# HISTORIC AND DESIGN REVIEW COMMISSION

June 05, 2019

**HDRC CASE NO:** 2019-243  
**ADDRESS:** 2218 W MAGNOLIA AVE  
**LEGAL DESCRIPTION:** NCB 6829 BLK 0 LOT 19  
**ZONING:** R-6, H  
**CITY COUNCIL DIST.:** 7  
**DISTRICT:** Monticello Park Historic District  
**APPLICANT:** Rufino Hernandez  
**OWNER:** Rufino Hernandez  
**TYPE OF WORK:** Exterior modifications  
**APPLICATION RECEIVED:** April 29, 2019  
**60-DAY REVIEW:** June 28, 2019  
**CASE MANAGER:** Huy Pham

**2218 West Magnolia**  
Historic Home Porch and Accessory Dwelling

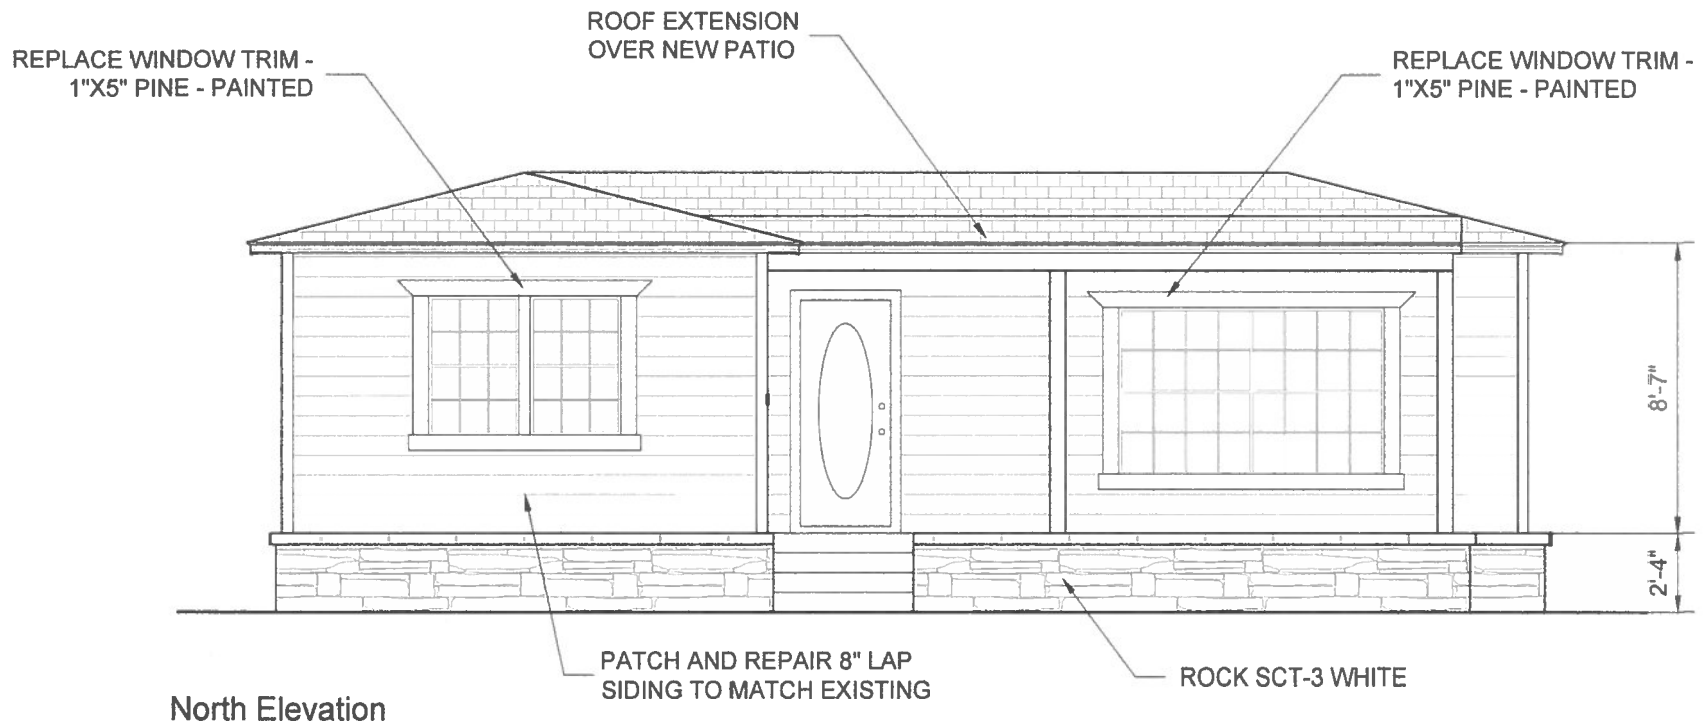
- d. PORCH INSTALLATION – The applicant has proposed to install a full width wood porch including shed roof cover over the existing concrete steps. The proposed porch features 2” by 6” members running parallel to the front façade plane and square wood columns. Per the Guidelines for Exterior Maintenance and Alterations 7.B.v., porches should be reconstructed based on accurate evidence of the original, such as photographs; if no such evidence exists, the design should be based on the architectural style of the building and historic patterns. Staff finds that the structure did not originally feature a porch and that the proposed porch is atypical for a structure of this style. Staff finds that the porch should be removed and the original concrete steps restored.

- g. REAR ACCESSORY STRUCTURE – The applicant has proposed to construct a 532 square foot rear accessory structure featuring a composition shingle roof, Hardie plank siding, five (5) vinyl windows, a nine-light steel door, a L-plan footprint, and a two-story square tower element.

Staff does not recommend approval of items 1 through 5 based on findings a through k. Staff recommends the applicant return the modified elements to their original condition and address the accessory structure’s inconsistencies with the Guidelines.

West Elevation

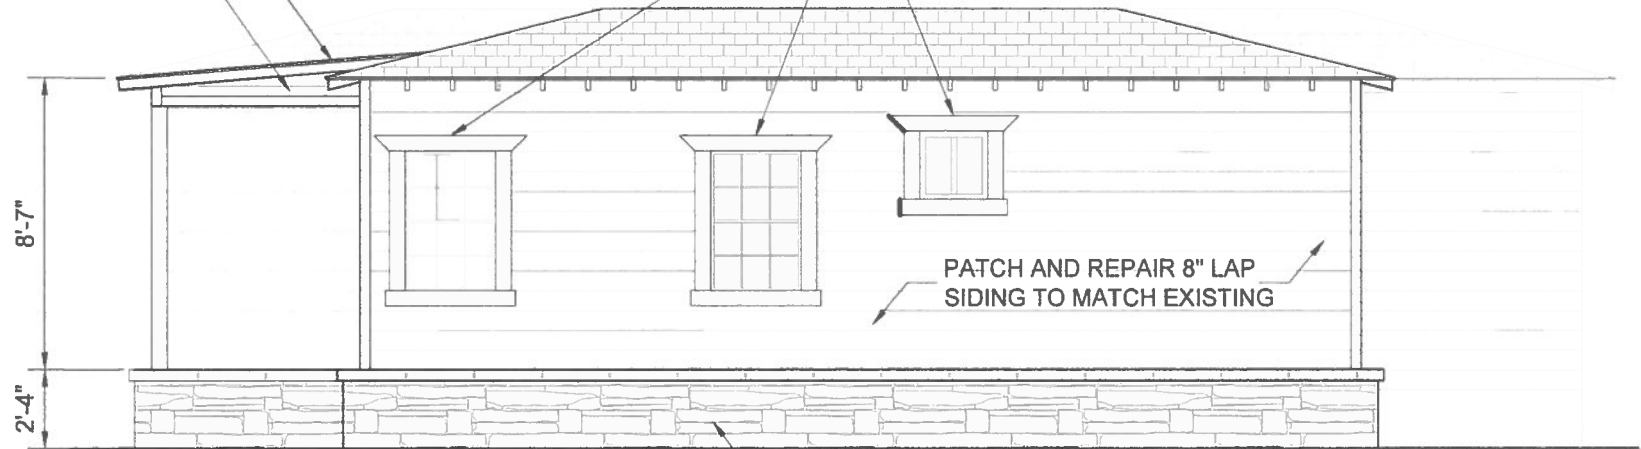
- e. SKIRTING MODIFICATIONS – The applicant has proposed to install limestone skirting throughout the structure. Per the Guidelines for Exterior Maintenance and Alterations 8.B.i., replacement skirting should consist of durable, proven materials, and should either match the existing siding or be applied to have minimal visual impact. Staff finds that the limestone skirting is a major departure from the minimal traditional style and should be removed. The structure should feature the simple exposed concrete skirting. Smooth Hardie plank with no faux wood grade may be installed at grade to prevent water infiltration.

- f. WINDOW TRIM – The applicant has proposed to replace the simple square window trim with a flared Craftsman style trim on all window through the structure. Per the Guidelines for Exterior Maintenance and Alterations 6.B.iv., window details should only be replaced in-kind when deteriorated beyond repair. Staff finds that the Craftsman detail is a departure from the minimal traditional style structure and should be reversed.

**2218 West Magnolia**  
Accessory Dwelling Unit

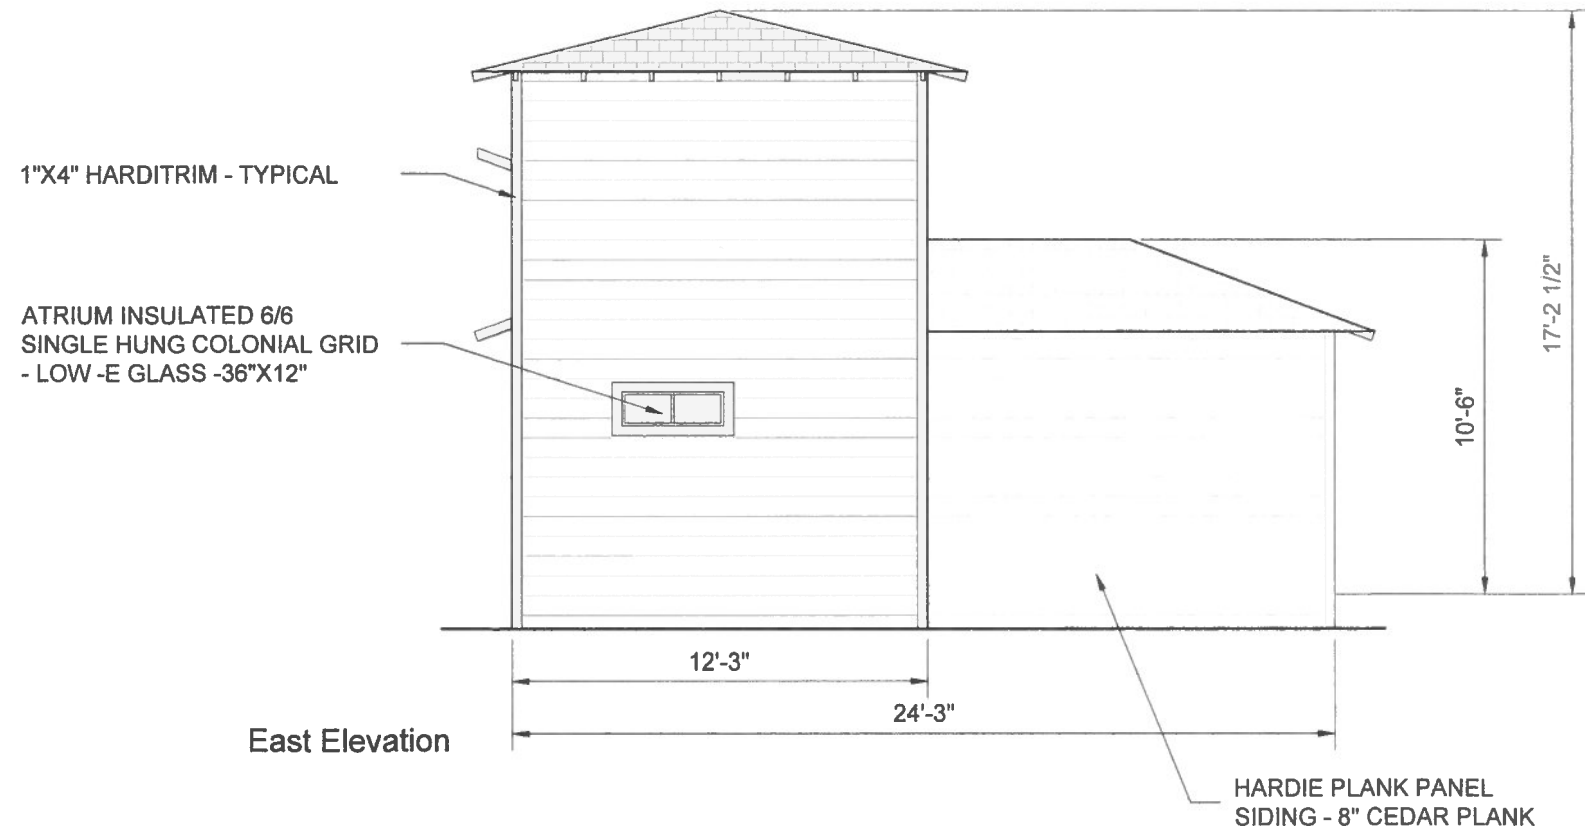
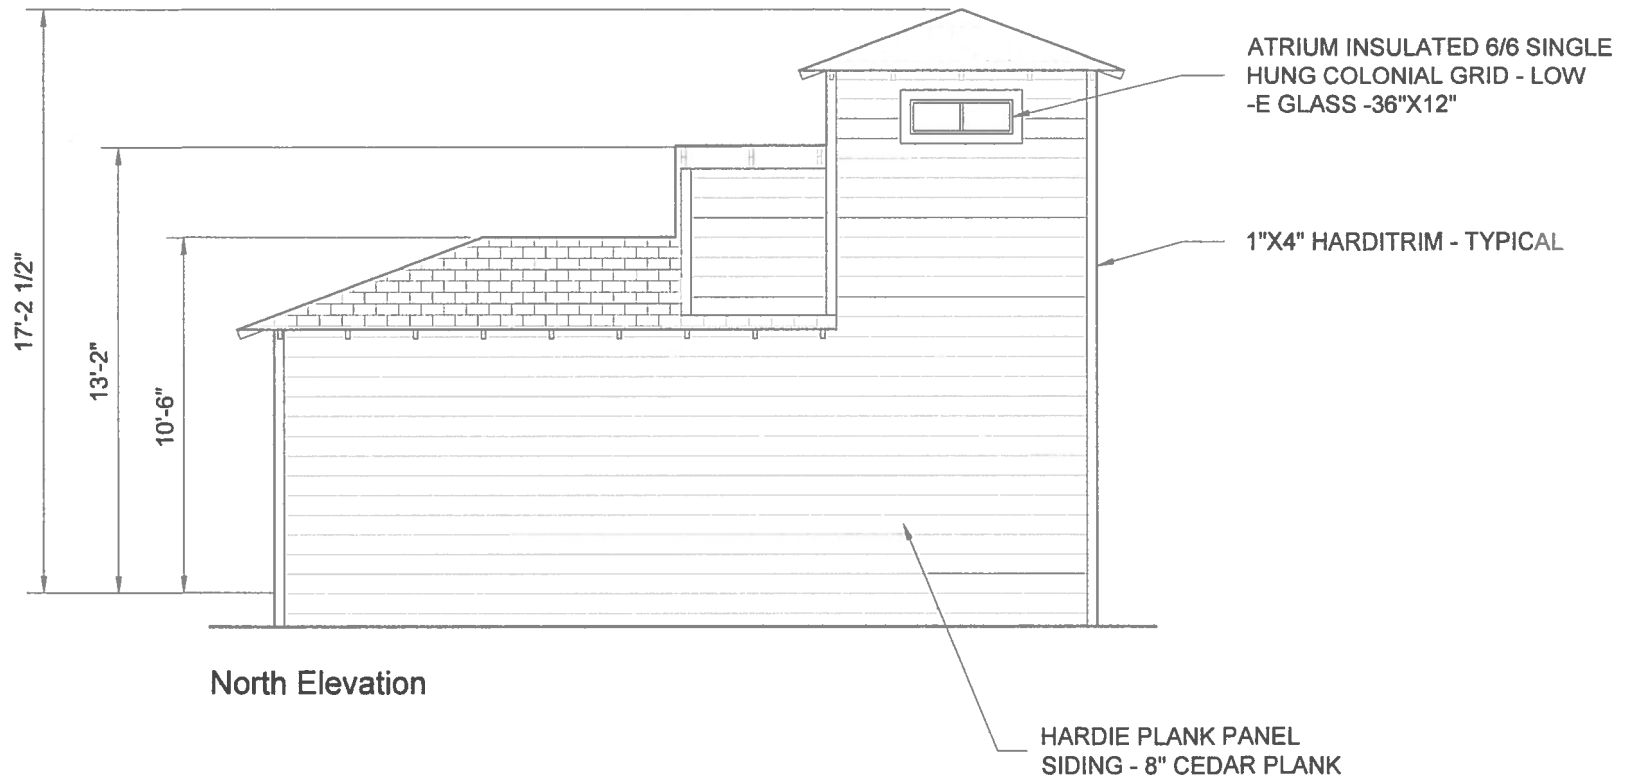
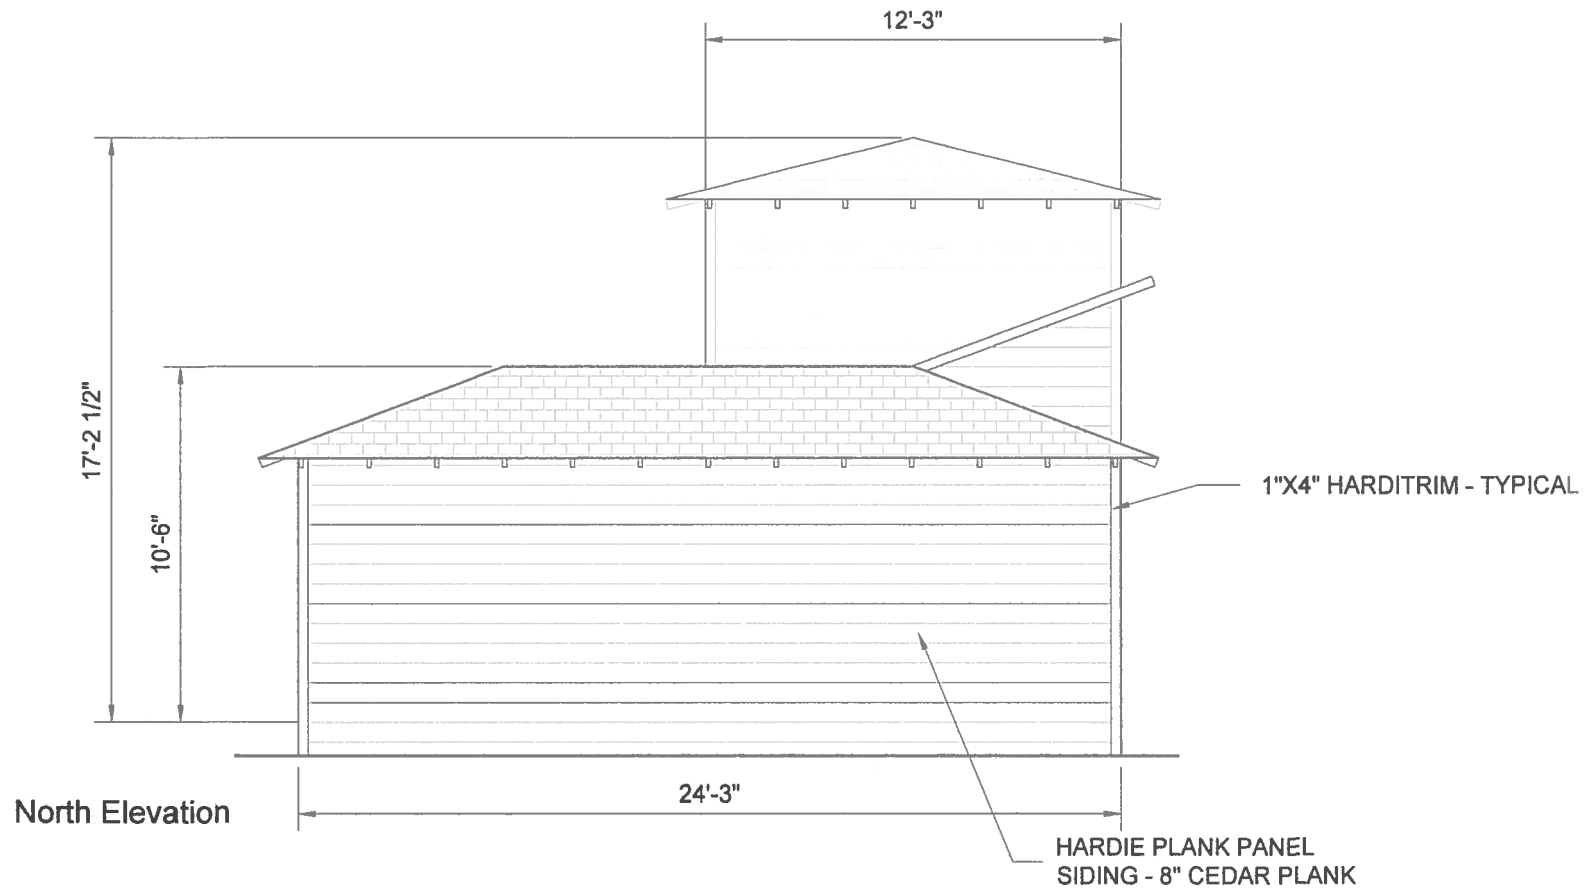
- h. ACCESSORY MASSING, FORM, AND SIZE – The proposed accessory structure features an L-plan with one portion featuring a two-story square tower element. The structure also includes a variety of roof forms and heights: the first floor front-facing hipped roof turns to a shed roof before meeting the second-floor pyramid roof of the tower element. Per the Guidelines for New Construction 5.A.i., new garages and outbuildings should be visually subordinate to the principal historic structure in terms of their height, massing, and form. Staff finds that the two-story tower element of the accessory structure to be generally appropriate provided it is located at the rear of the lot and is minimally visible from the public right of way.

- i. ACCESSORY CHARACTER AND DESIGN – Per the Guidelines for New Construction 5.A.iii., new garages and outbuildings should relate to the period of construction of the principal building on the lot through the use of complementary materials and simplified architectural details. Excluding the use of composition shingles, divided light of windows, and lap siding, staff finds that the multiple roof forms, footprint, fenestration details regarding vinyl window size and configuration, door styles, and general massing is a major departure from the minimal tradition primary historic structure.

- j. ACCESSORY DOORS AND WINDOWS – Per the Guidelines for New Construction 5.A.iv., window and door openings should be similar to those found on historic garages or outbuildings in the district or on the principle historic structure in terms of their spacing and proportions. Staff finds that the use of square windows and sliding horizontal windows, the two different door styles, and the general spacing of fenestration elements to be a major departure from historic garages and outbuildings in the district and the minimal traditional primary historic structure. Additionally, staff finds that accessory structure windows should relate to the primary structure by featuring wood or aluminum-clad wood with exterior divided light details matching in trim and the standard stipulations: *Meeting rails that are no taller than 1.25” and stiles no wider than 2.25”*. *White manufacturer’s*

- k. ACCESSORY ORIENTATION AND SETBACKS – Per the Guidelines for New Construction 5.B.ii., new accessory structure should utilize the historic setback pattern of similar structures along the streetscape or district for new garages and outbuildings; historic garages and outbuildings are most typically located at the rear of the lot, behind the principal building. In some instances, historic setbacks are not consistent with UDC requirements and a variance may be required. The applicant has proposed to construct the accessory structure in the rear corner of the property with a 5-foot setback line. Staff finds that the generally orientation and setback is consistent with the guidelines and existing accessory structure on E Magnolia. However, the applicant is responsible for complying with all UDC requirements for setbacks and obtaining a variance if necessary.
